PLANNING REPORT - Major Site and Building Plan Review

RE: Sunfish Lake – 2250 Delaware Avenue – Site and Building Plan Review

Re: Major Site and Building Plan Review
2250 Delaware Avenue
City of Sunfish Lake, MN
WSB Project No. 1629-79

CERTIFICATE OF SURVEY

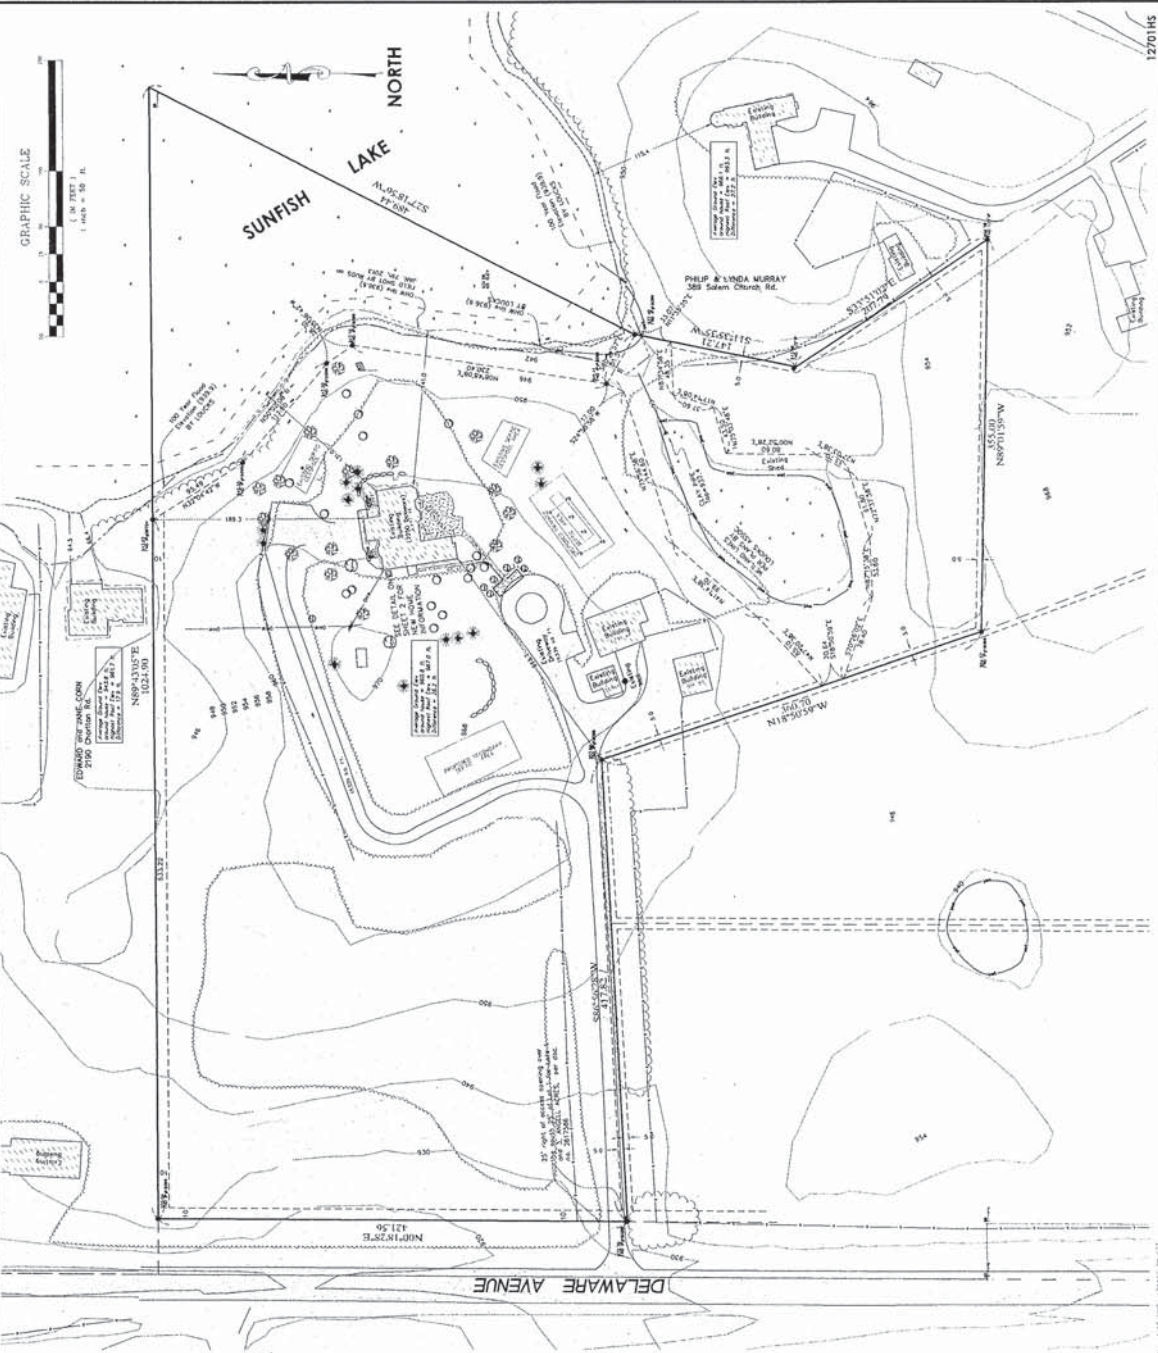
Stormwater Management. The applicant submitted a site survey illustrating drainage on the site in association with the proposed home and garage. Drainage along the north, east, and south portions of the home will move towards the lake, and drainage on the west side of the home will move overland towards Delaware Avenue. Water draining south of the home will first settle in a vegetated wetland near the shoreline, before moving through a pipe to the lake. The parcel hosts a significant amount of tree coverage surrounding the home and adjacent to the shoreline. This natural cover will aid in slowing the movement of stormwater runoff towards the lake. Additional stormwater treatment measures nearer the home can help intercept stormwater runoff at its origin.

Planning staff suggests the installation of a raingarden planted to the east of the new driveway, which would help mitigate runoff from the driveway's surface. The demolished driveway located east of the new driveway (between the new driveway and the lake) would serve as an opportune location for a new raingarden; both because it sits lower in elevation than the new driveway (so that water moving off of the new driveway will pass by the area on the way to the lake), and because this location will be in transition in the course of construction activities (it will need to be demolished and restored in order to create the new driveway). Another option for improvement includes increasing the vegetated buffer along the shoreline to include additional low growing natural vegetation where none currently exists. The DNR or local water and soil conservation district can provide advice as to appropriate species.

- b) A raingarden located between the new driveway and the lake (in the area of the demolished driveway), to mitigate stormwater runoff flowing off of the driveway and nearby building surfaces towards the lake.

Exhibit D - First Floor Plan

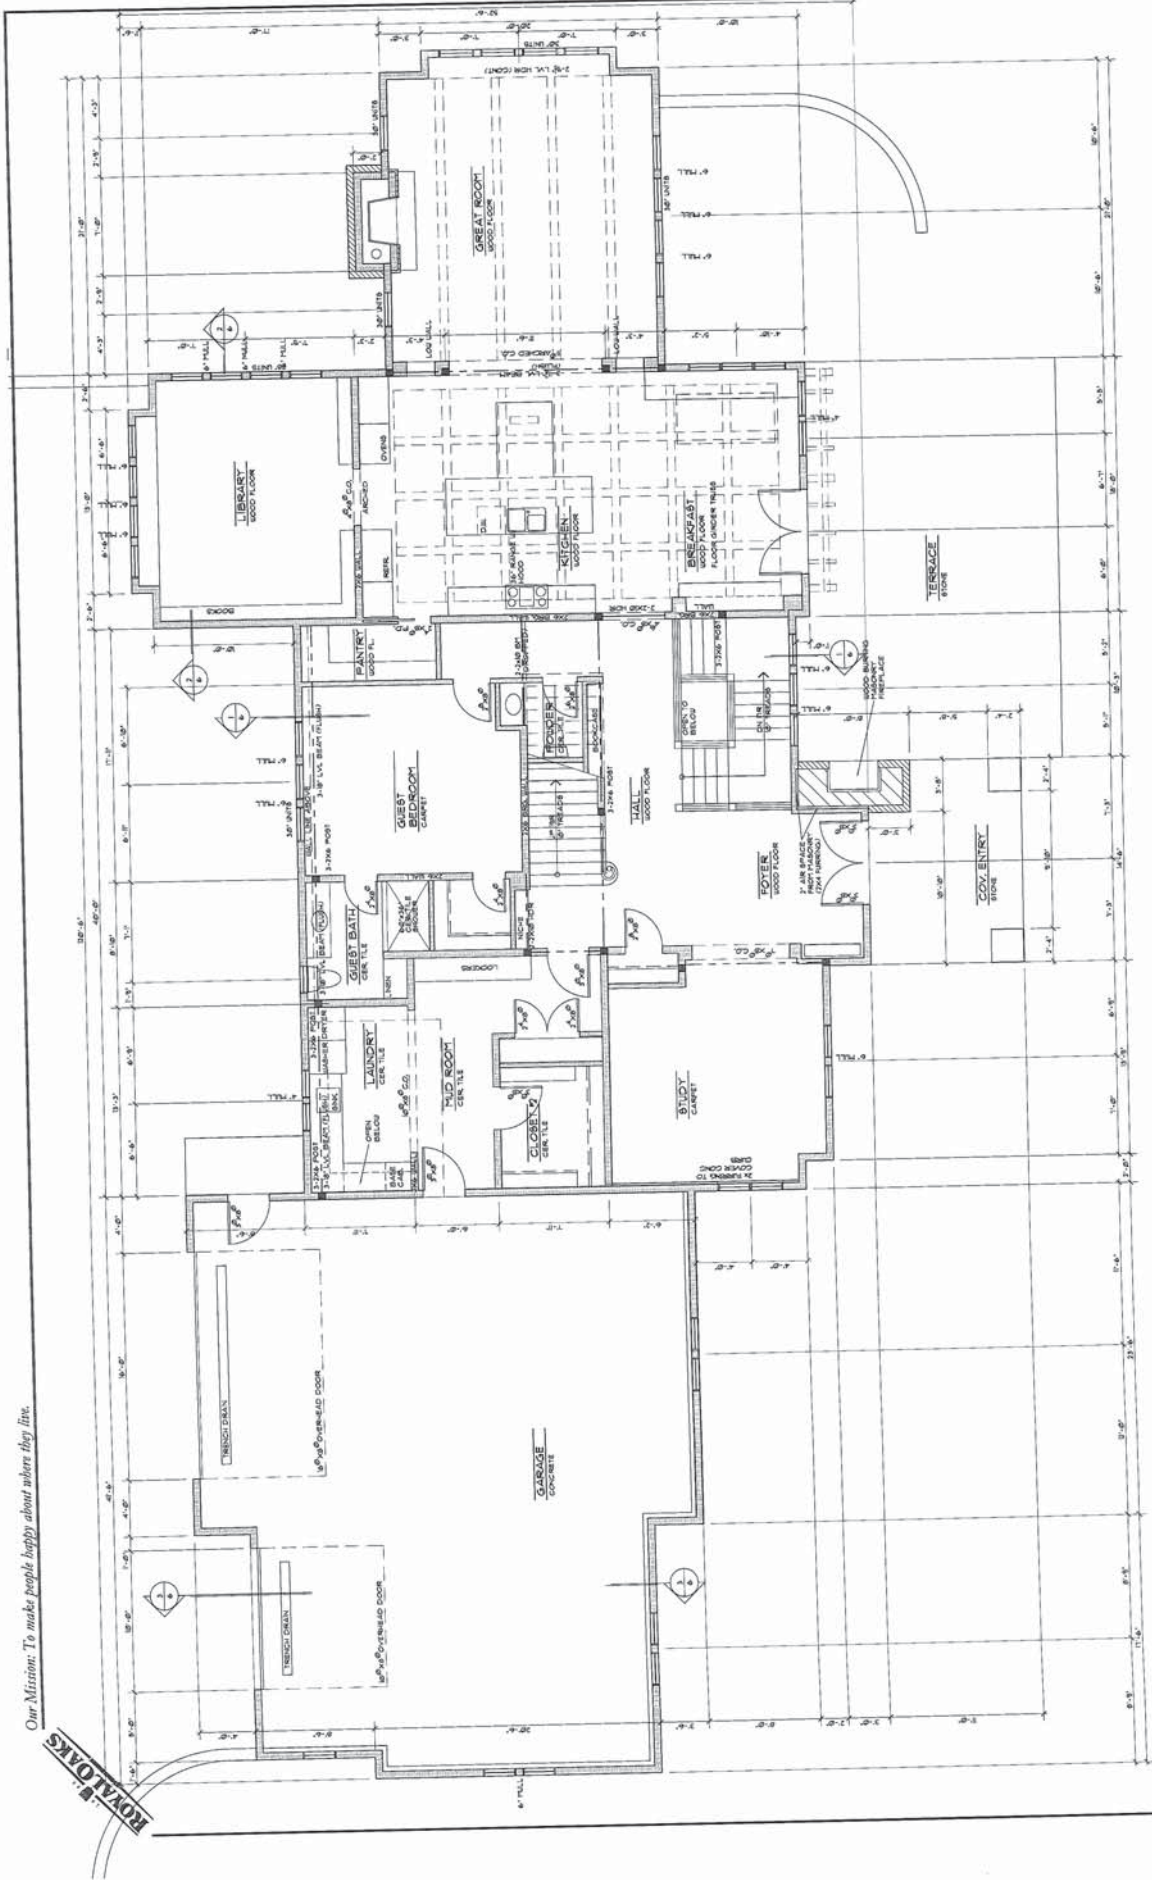
Accessory Buildings. An attached garage not exceeding 1,250 square feet (first floor) shall be considered an integral part of the principal building. However, the building plans indicate that the attached garage will be 1,357 square feet in area, which is 107 square feet larger than Ordinance permits. The applicants will need to demonstrate that the attached garage has been reduced down to a maximum of 1,250 square feet in area as a condition of approval.

3. The applicant shall provide revised building plans demonstrating that the attached garage has been reduced down to a maximum of 1,250 square feet in area.

Landscape Plan: Landscape Concept Plan
2550 Delaware Ave Sunfish Lk

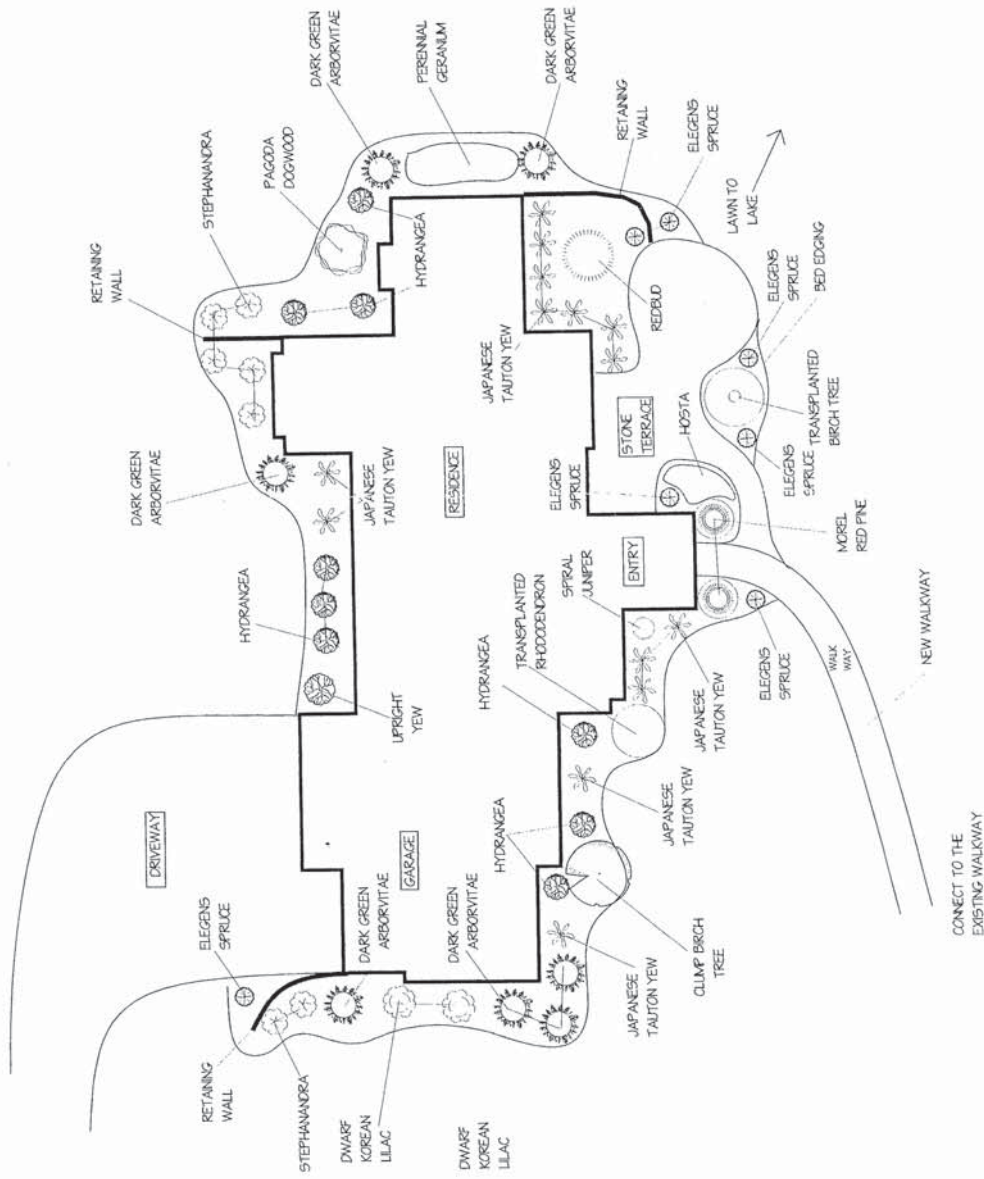
Placement and Design of Roads, Driveways, and Parking Areas. According to the Ordinance, private roads and parking areas shall be designed to take advantage of natural vegetation and topography to achieve maximum screening from view from public waters. The driveway and parking lot area are located north of the house, and west of the location of the existing driveway on the property (placing it farther from the lake). While the driveway is located uphill from the lake, so that it will be visible from the lake to some extent, a few mature oak and maple trees exist between the lake and the proposed driveway providing a limited screening effect. No shrubs or perennials have been proposed in the landscape plan to the east of the driveway in the direction of the lake; incorporating these in the landscape plan would provide a more immediate

screening effect on the parking area, as well as function to slow stormwater runoff from impervious surfaces associated with the home and garage.

2. A revised landscape plan which incorporates:
 - a) An area of shrubs and perennials to the east of the driveway, in the direction of the lake, to provide improved screening for the parking area.
